ADDENDUM NO. 2 TO PROJECT NO. #47337

**CONSTRUCTION, HVAC, PLUMBING AND ELECTRICAL WORK
PROVIDE ADDITION & WILDLIFE TISSUE DIGESTER
DELMAR FISH AND
WILDLIFE BUILDING
108 GAME FARM ROAD
DELMAR, NY**

December 5, 2025

DWG NO:
AD-02.01

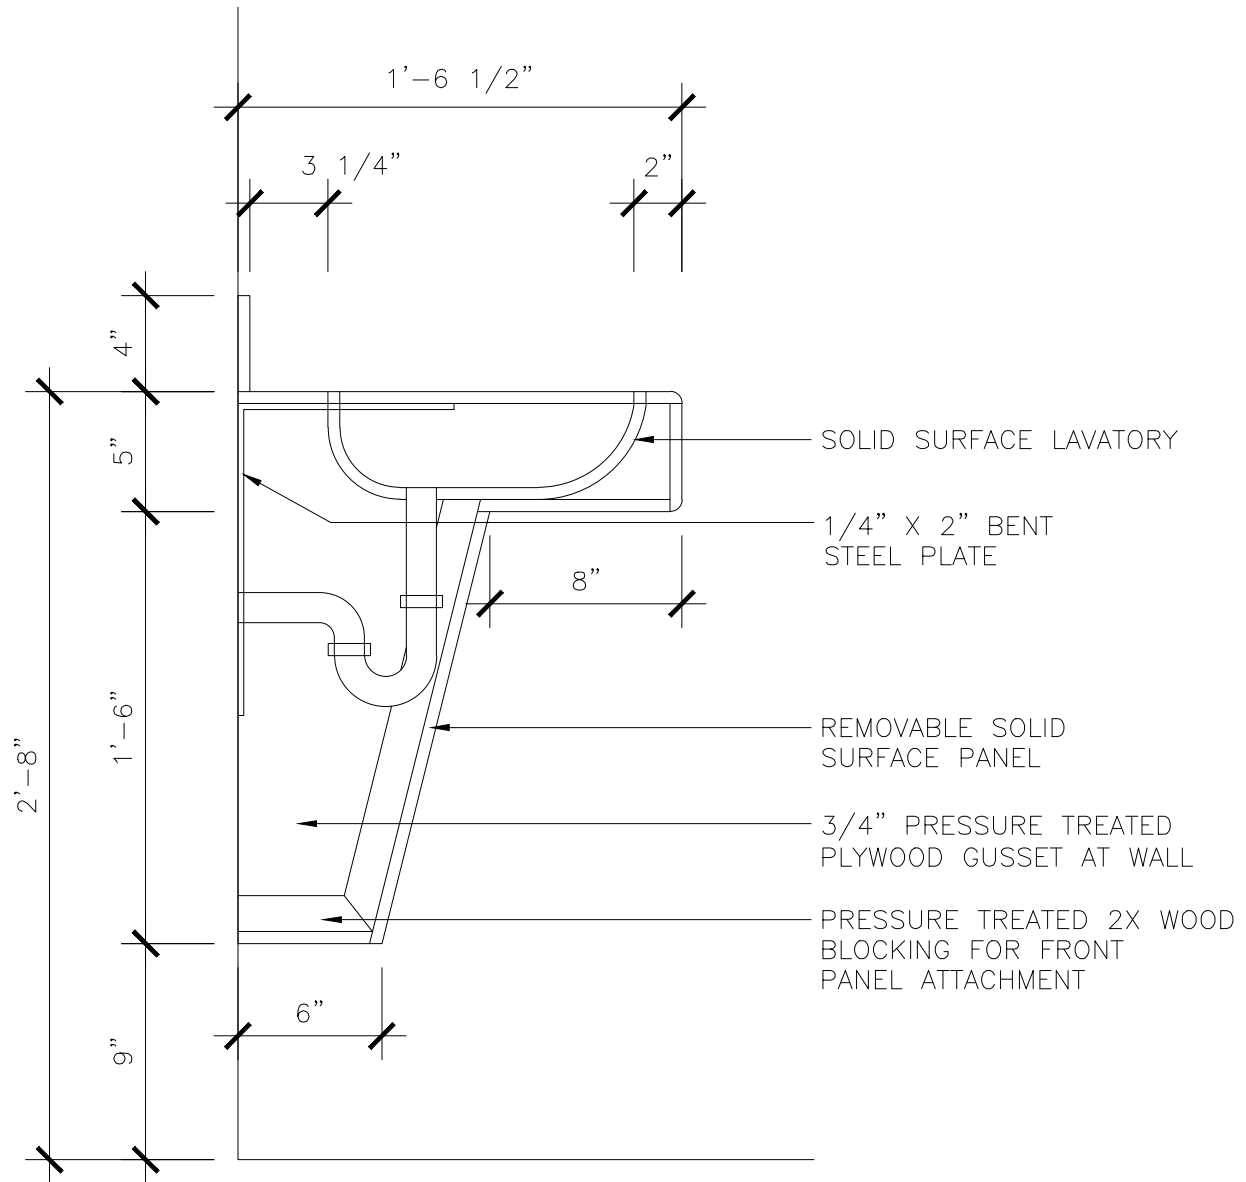
- 4) Room 01 STORAGE: Replace “RB Base” with “EPOXY Base”
10. Addendum Drawing:
 - a. Drawing No. AD 02.01 noted “12/01/25” accompanies this Addendum and forms part of the Contract Documents.
